**DISCONTINUATION OF USE / QUARANTINE:
VST2 VG11 FALL ARREST CARRIAGE FROM NEW TECHNELEC**

Discontinuation of use and quarantine of batches of VST2 VG11 fall arrest carriage from NEW TECHNELEC assembled in May 2024 (reference 10/2021) due to non-compliance of a batch of SKYLOTEC energy absorbers with a proven risk to the end user. Immediately stop using the carriages affected by this recall.

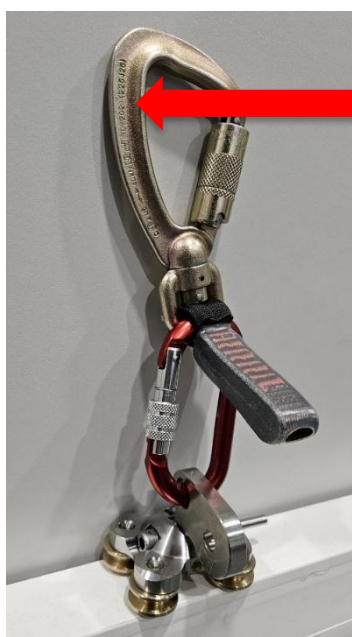
During tests conducted by the certification body for the purpose of obtaining the C2 module, a non-conformity was identified in the SKYLOTEC energy absorber, a textile component assembled on the VST2 VG11 carriage.

We would like to point out that the design and manufacture of the carriage itself are not in question. Only the SKYLOTEC energy absorber attached to the carriage is non-compliant.

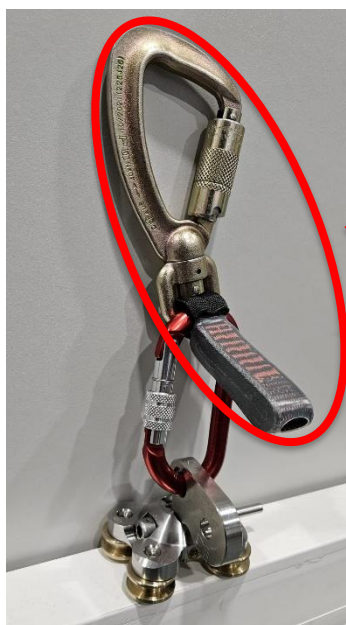
To correct this non-compliance, the energy absorber and the carabiner to which it is sewn must be replaced as shown in the picture below:

The items circled must be replaced:
SKYLOTEC upper carabiner + the
textile energy absorber sewn onto it.

The NEW TECHNELEC teams will contact you shortly to provide detailed information on the implementation of the corrective solution.
